7-11 C-STORE WITH CAR WASH AT CROSS CREEK AVENUE SITE PLAN WITH CONDITIONAL USE

7-ELEVEN AT CROSS CREEK
 LOT 1, BLOCK 1, CROSS CREEK 1ST AVENUE SUBDIVISION, AURORA, COLORADO
SITE PLAN

VICINITY MAP

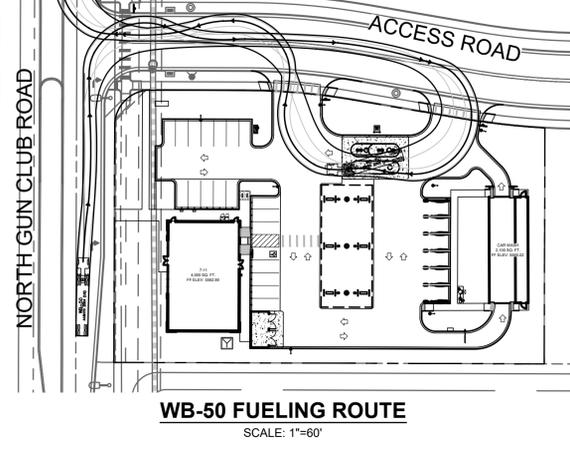
Please show compliance to the 2015 IFC Amendment 66-33 limiting Fuel Dispensing Facilities Stations to within 500 feet of an E, I, or R-4 Occupancy.

Make vicinity map larger to show the nearest major intersection and all surrounding local streets and change to black and white for better readability

500' distance has been shown on vicinity map

Vicinity map increased in scale and changed to parcel linework for legibility

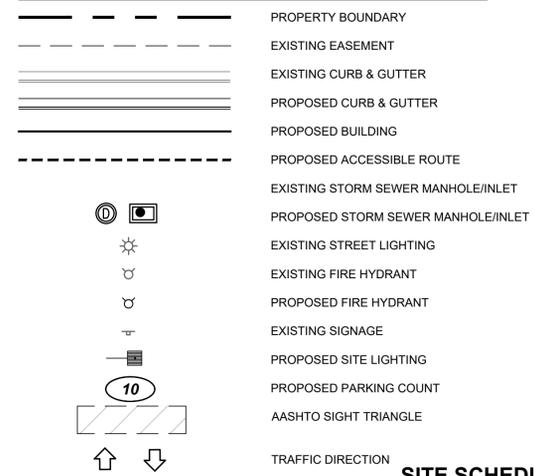
monument sign has shifted out of easement
 this portion of the monument sign is encroaching into the easement. Contact Grace Gray (ggray@auroragov.org) to start the process

Sidewalk has been updated, dimension added.
 The sidewalk is detached here. Adjust leader to "existing" sidewalk and provide dimension

patio details have been included. Dimensions added to plan
 Show seating/tables in patio area. Dimension.

Please add curb stop to protect accessible sign.
 curb stop included in design and added to schedule
 Dimension the C-store and car wash buildings
 building and car wash have been dimensioned

Please label the underground Fuel Tanks with the contents and Gallonage; for example, 20,000 Gallon Split Tank 10,000 RUL/10,000 Diesel.

Dimension "existing" sidewalk
 sidewalk has been dimensioned

Dimension the C-store and car wash buildings
 Car wash and building have been dimensioned

verbiage has been revised, callouts have been split up

7-ELEVEN AT CROSS CREEK
LOT 1, BLOCK 1, CROSS CREEK 1ST AVENUE SUBDIVISION, AURORA, COLORADO
GRADING AND UTILITY PLAN

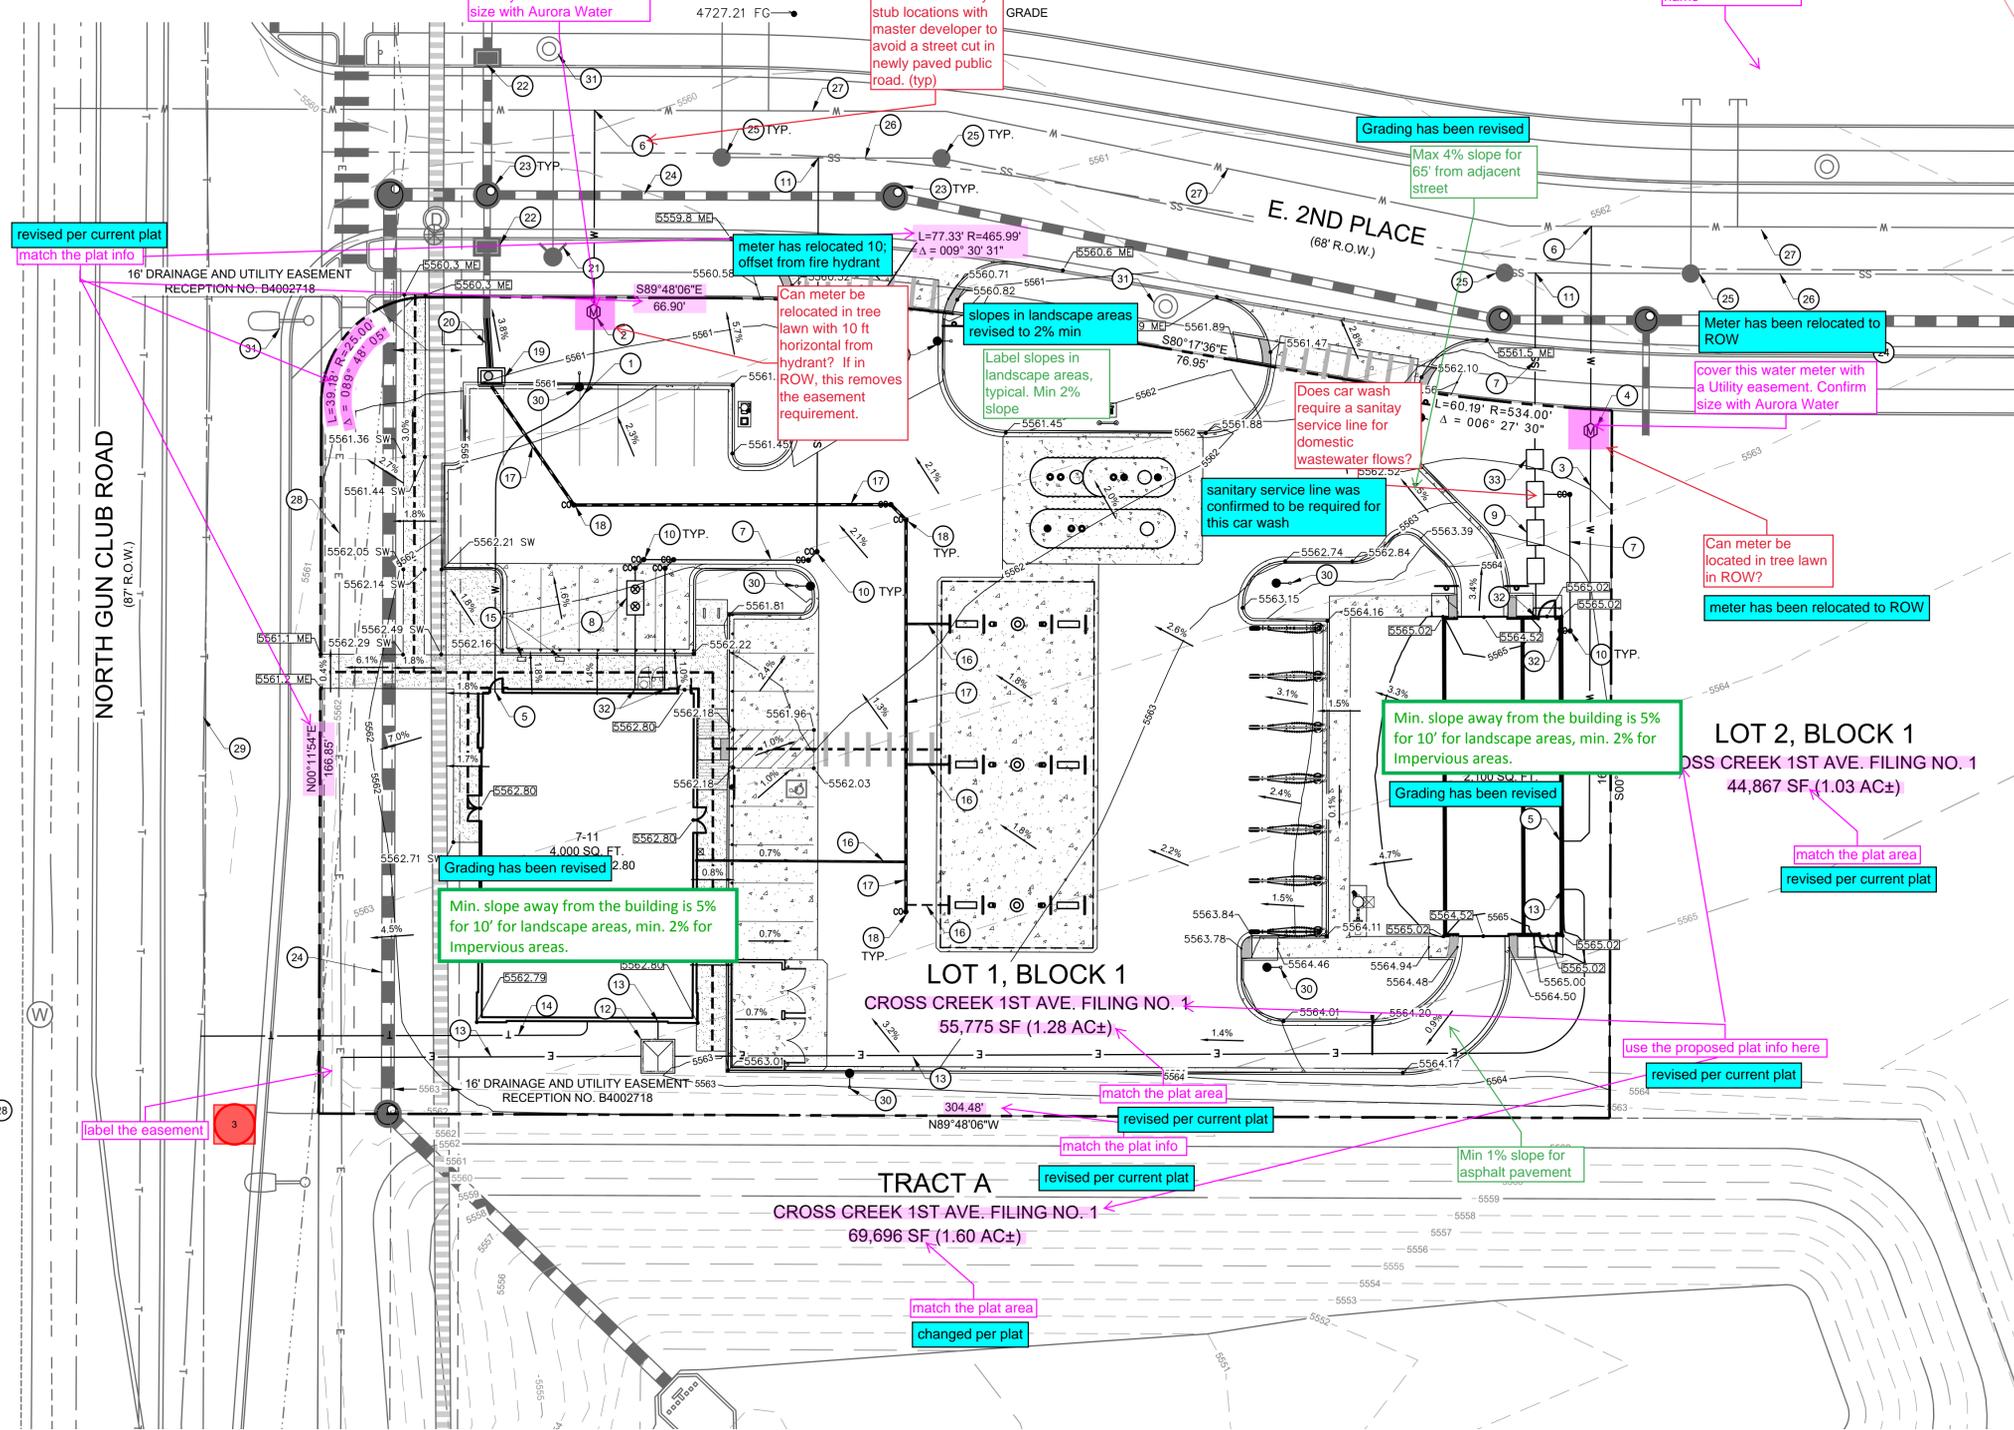
Grading has been revised
Max 4% slope for 65' from adjacent street

Meter has been relocated to ROW
cover this water meter with a Utility easement. Confirm size with Aurora Water

coordination with overall developer is ongoing for proposed stub location
Confirm water, storm and sanitary stub locations with master developer to avoid a street cut in newly paved public road. (typ)

Can meter be relocated in tree lawn with 10 ft horizontal from hydrant? If in ROW, this removes the easement requirement.

slopes in landscape areas revised to 2% min
Label slopes in landscape areas, typical. Min 2% slope

Does car wash require a sanitary service line for domestic wastewater flows?
sanitary service line was confirmed to be required for this car wash

Can meter be located in tree lawn in ROW?
meter has been relocated to ROW

Min. slope away from the building is 5% for 10' for landscape areas, min. 2% for impervious areas.
Grading has been revised

Acknowledged
Fixture unit table will be required at civil plans to confirm meter size.

Acknowledged
2 inch water meter requires a domestic service allocation agreement prior to generating meter fees.

PLANTING PLAN

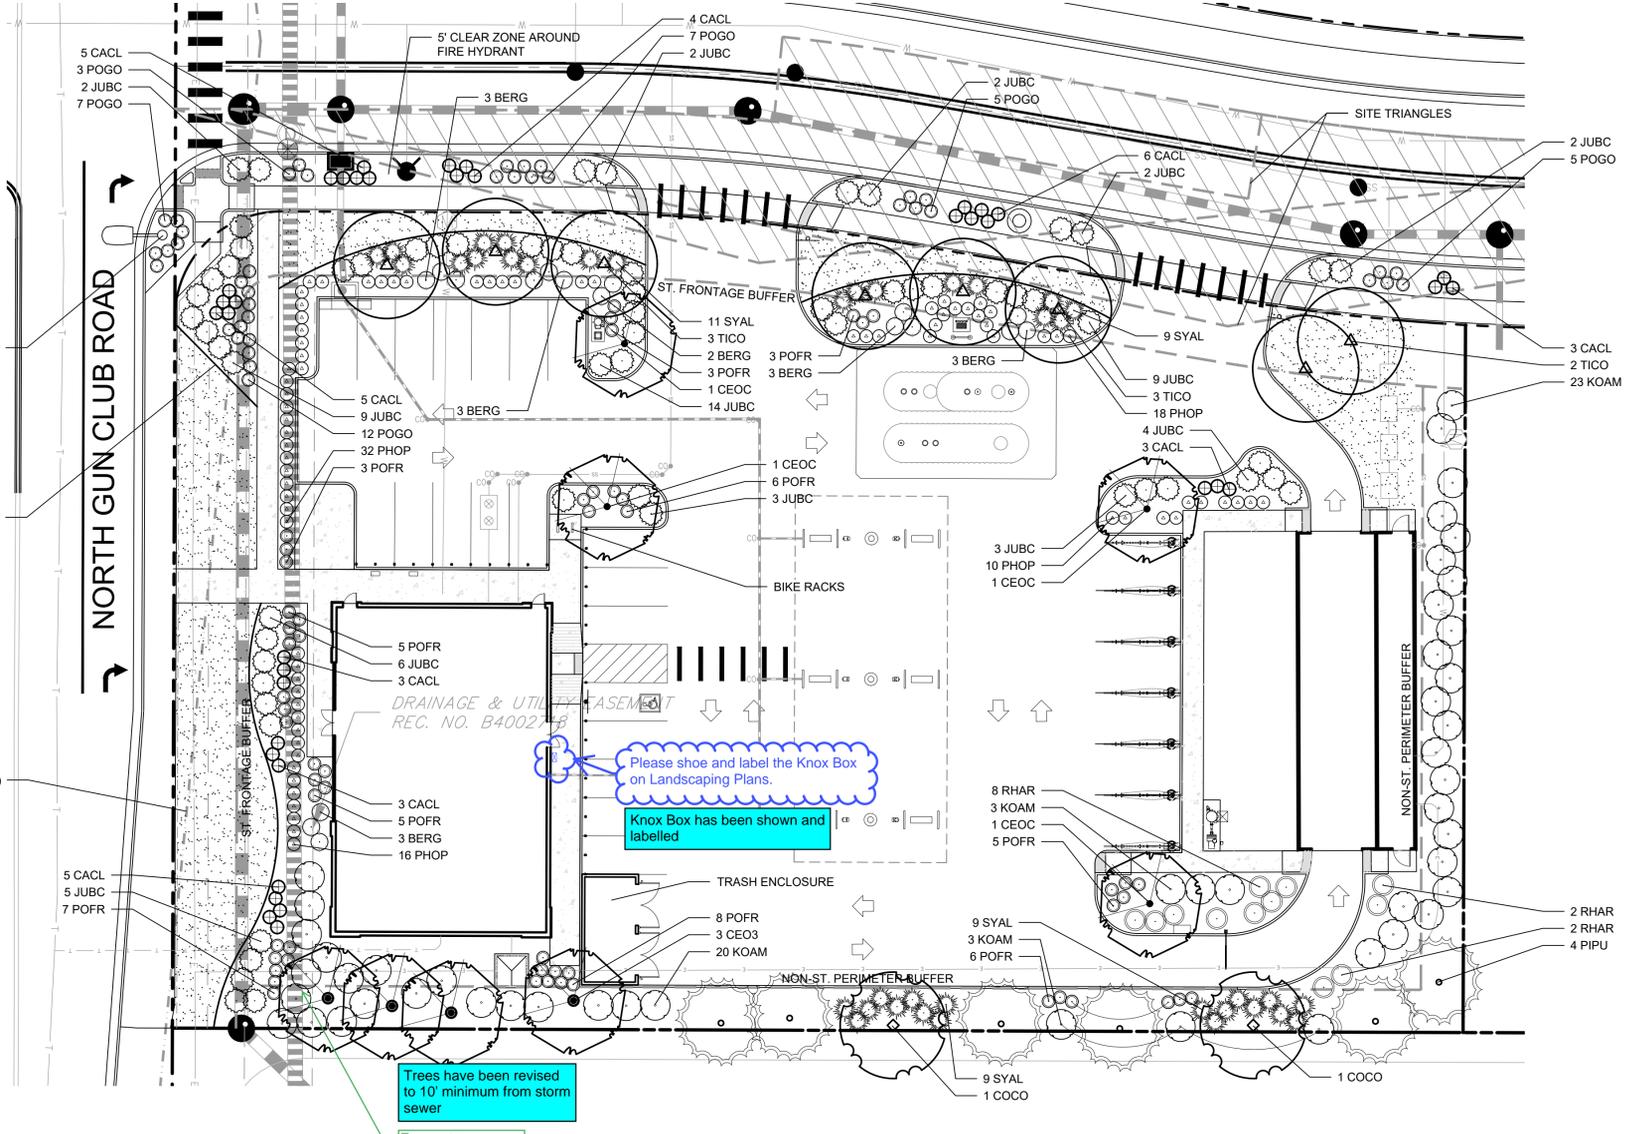
Please shoe and label the Knox Box on Landscaping Plans.
Knox Box has been shown and labelled

Trees have been revised to 10' minimum from storm sewer
 Ensure trees are a minimum 10' away from storm sewer

Please add the Accessible Sign Package to the Site Plan.

Information moved to site plan

Project Name: 7-11 #42018 Aurora, CO - 6th & Gun Club

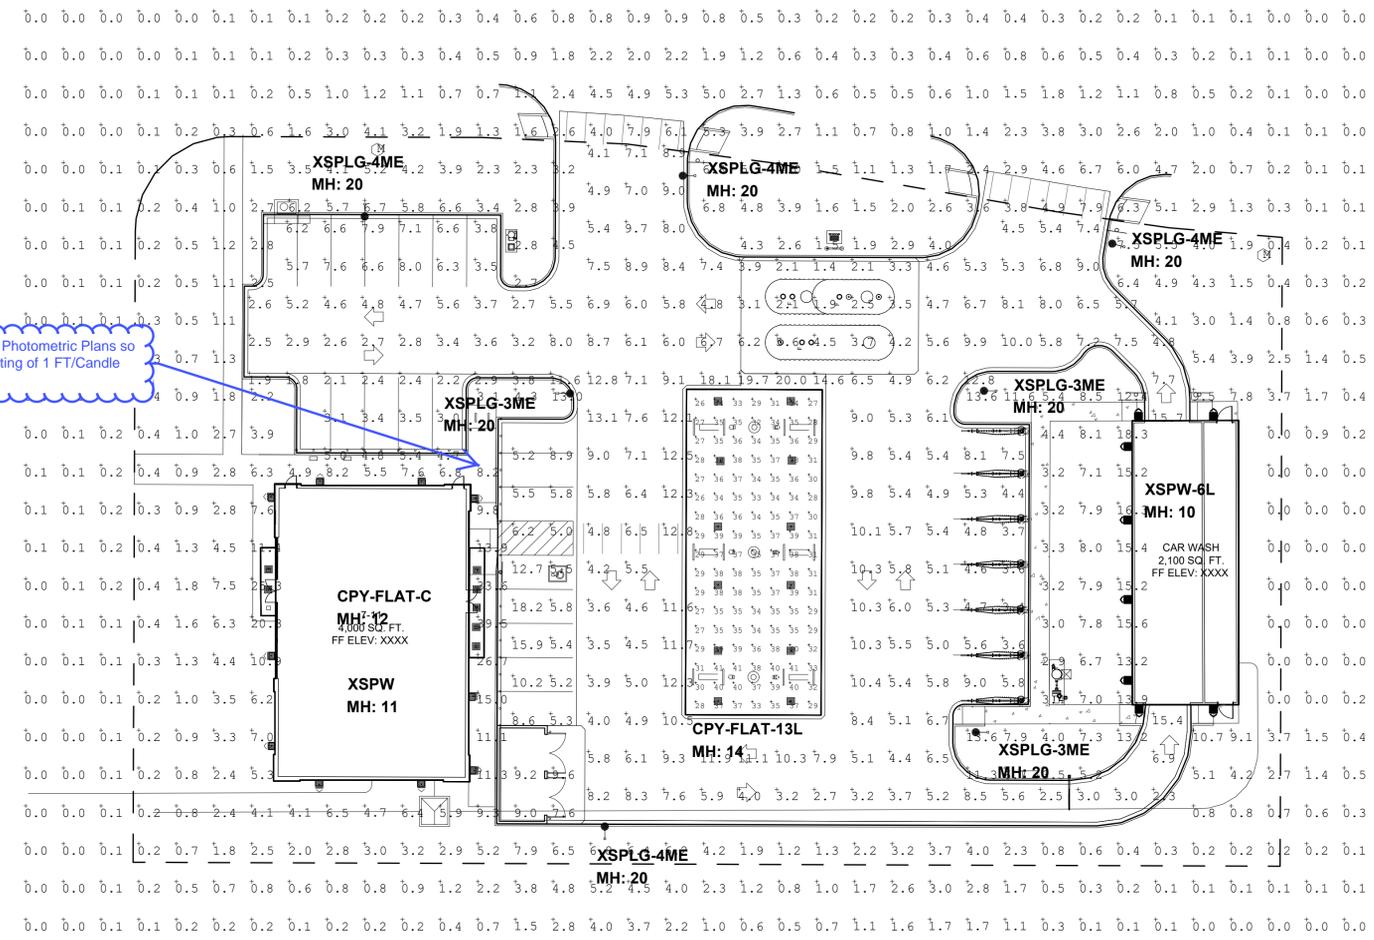
Please add the Accessible Route to the Photometric Plans so we can verify the required minimum lighting of 1 FT/Candle along the entire route. See Sheet P1.0.

Accessible route has been included
